3.4-1 Public Sewage

Figure 3.4-1: Location of Proposed Wastewater Treatment Facility
 Raleigh and Heiden Properties
 Town of Fallsburg, Sullivan County, New York
 Site Plan: Glenn L. Smith Consulting Engineer, P.C., 02/10/11
 Scale: As shown

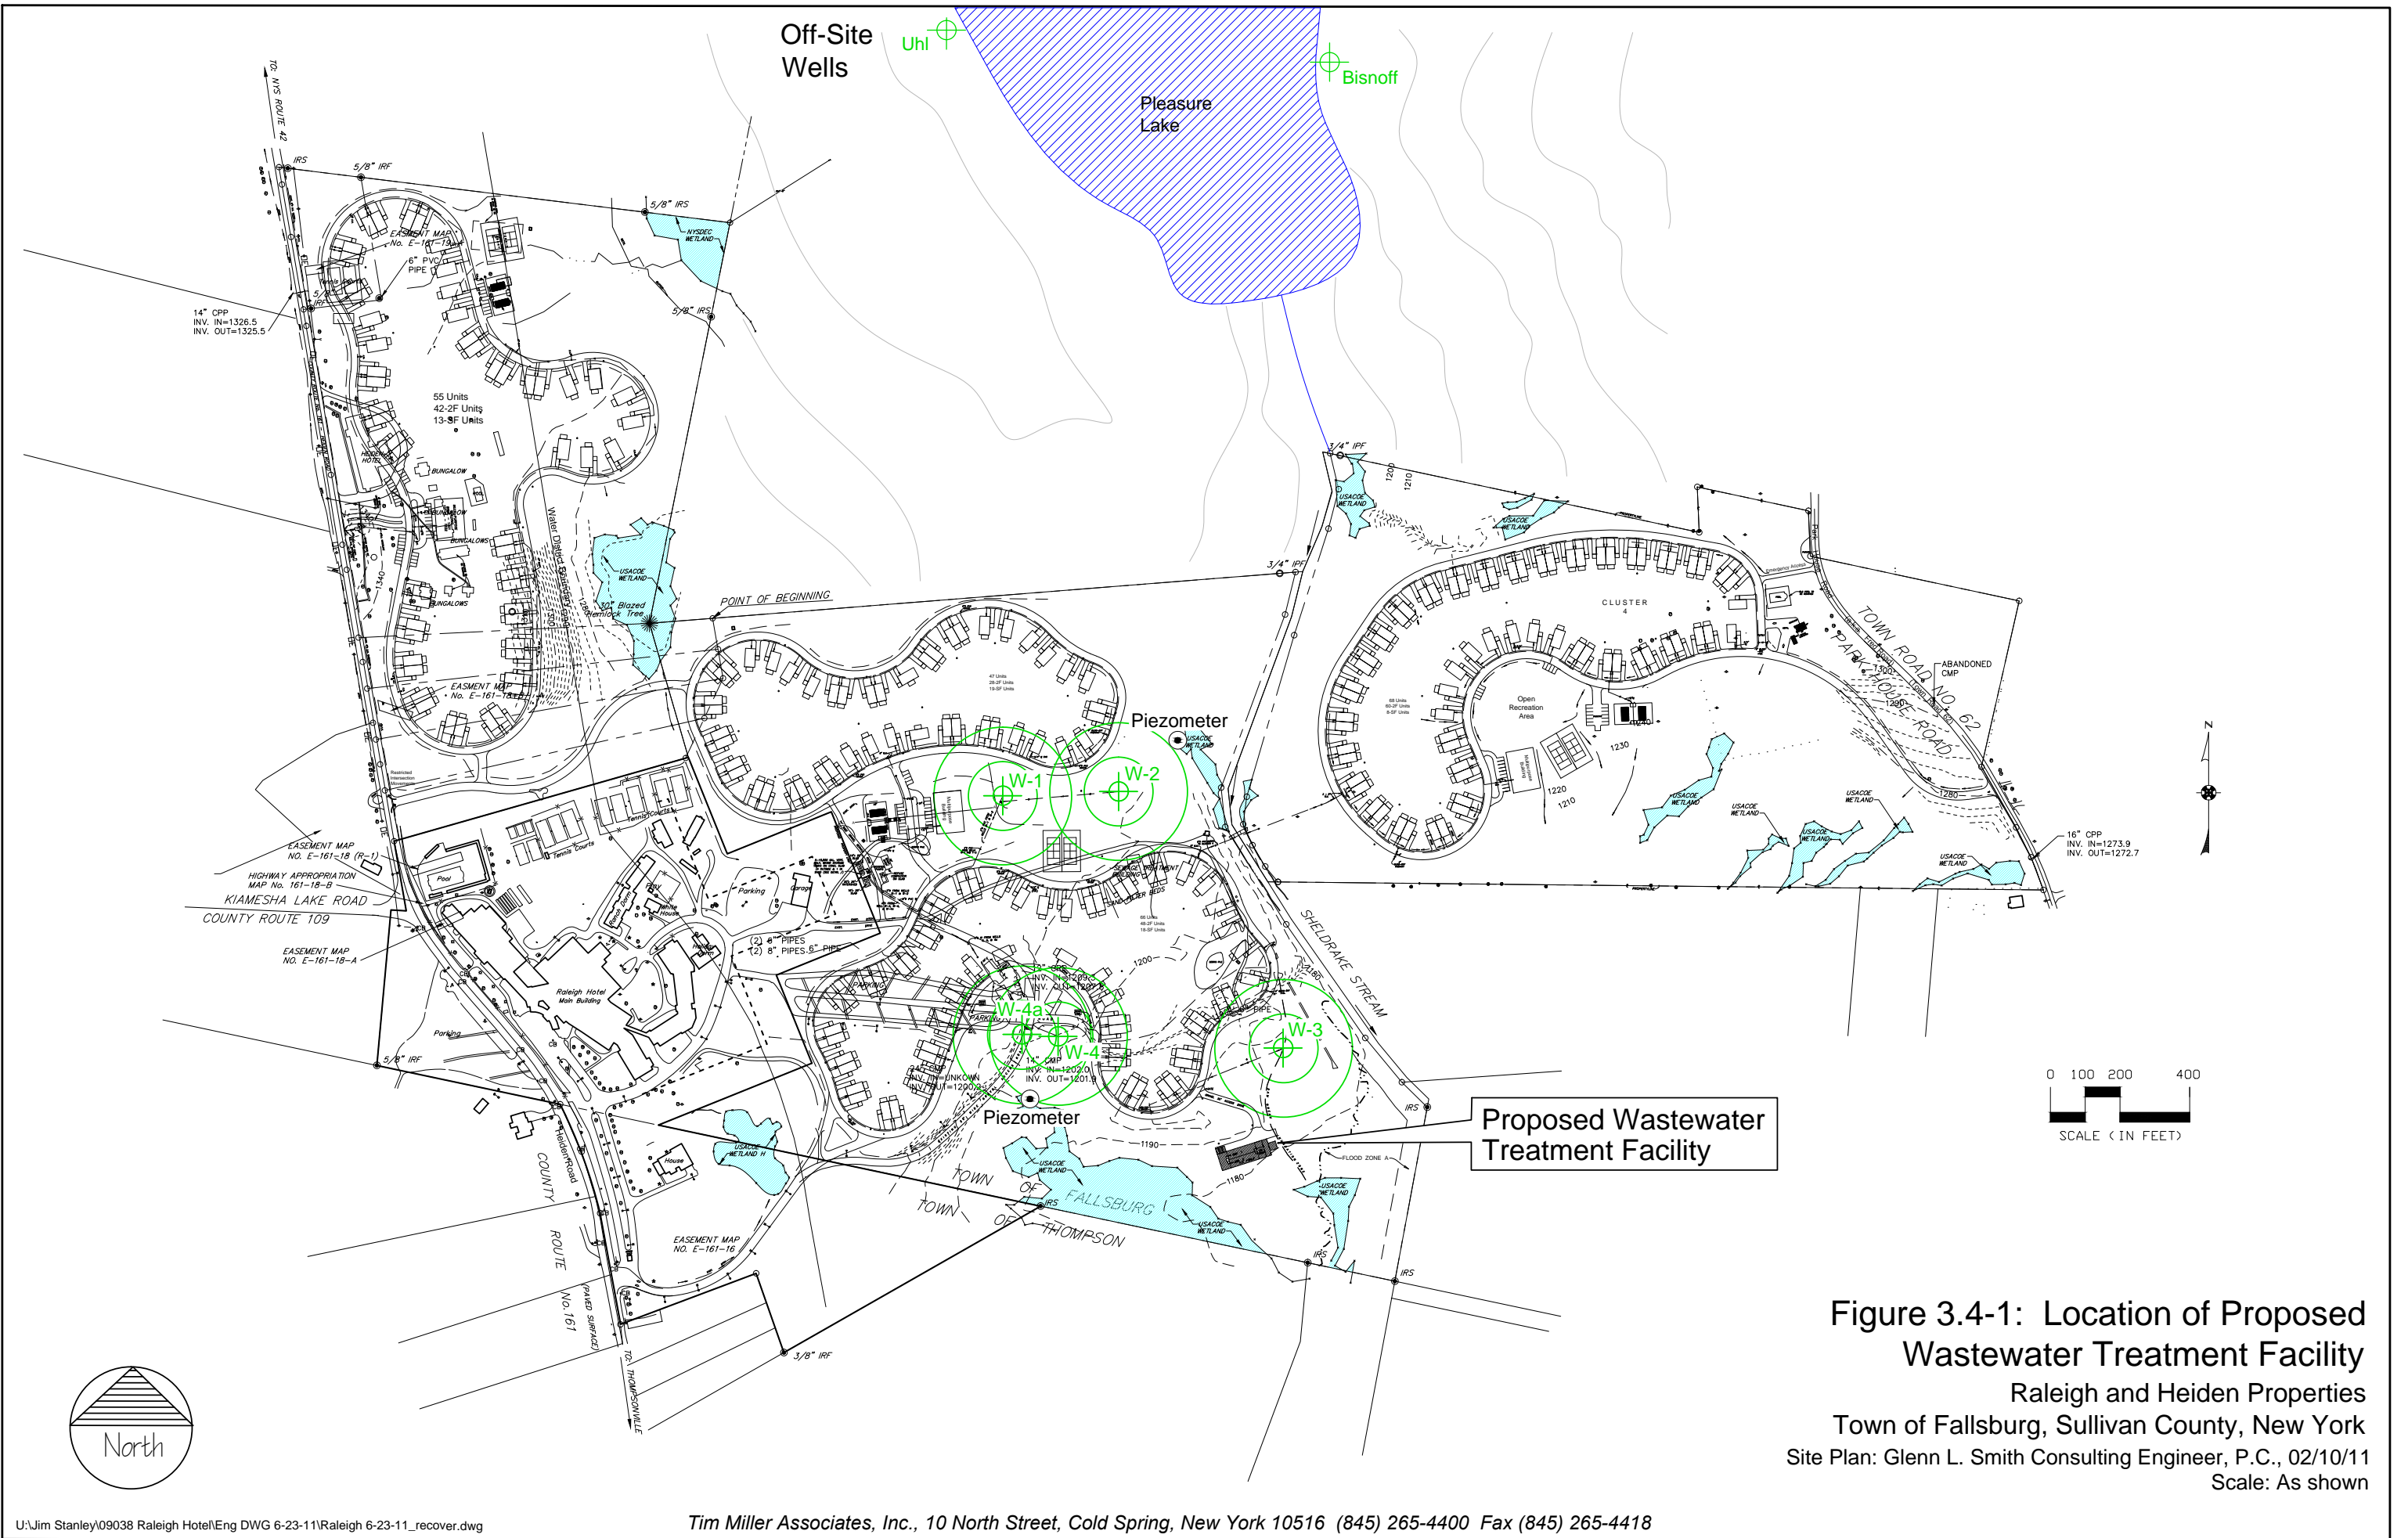
Comment 3.4-3 (Letter to Planning Board, December 16, 2011, Fallsburg Fishing and Boating Club, James Creighton): In addition, sewage should not be pumped via a force main under the Sheldrake Stream, but a separate independent sewage treatment facility should be built on the east side of the Sheldrake Stream in order to serve the wastewater needs for the cluster on that side of the stream.

Comment 3.4-5 (Letter to Planning Board, December 10, 2011, Jerry Chiochio): Impact on the stream exiting Pleasure Lake: I understand that the sewage and water are planned to be routed under the stream. I urge you to reconsider this as it can pose danger to the stream if a sewage line erupts. It will contaminate the stream effecting the fish and wildlife. As a result, I am urging the planning board to only approve a separate well and sewage treatment building (Park House Road Building) on the other side of the stream in order to minimize the risk.

Response 3.4-4: NYSDEC regulations and guidance policy does not permit the construction of multiple wastewater treatment plants but stresses consolidation of multiple property discharges to one central facility. Installing a small diameter sewage force main pipe under Sheldrake Stream from cluster 4 to the proposed S.T.P. near Cluster 3 is preferred by NYSDEC, subject to a stream disturbance permit from that agency (See Response 3.2-20)

Response 3.4-5: Refer to Response 3.4-4 (above)
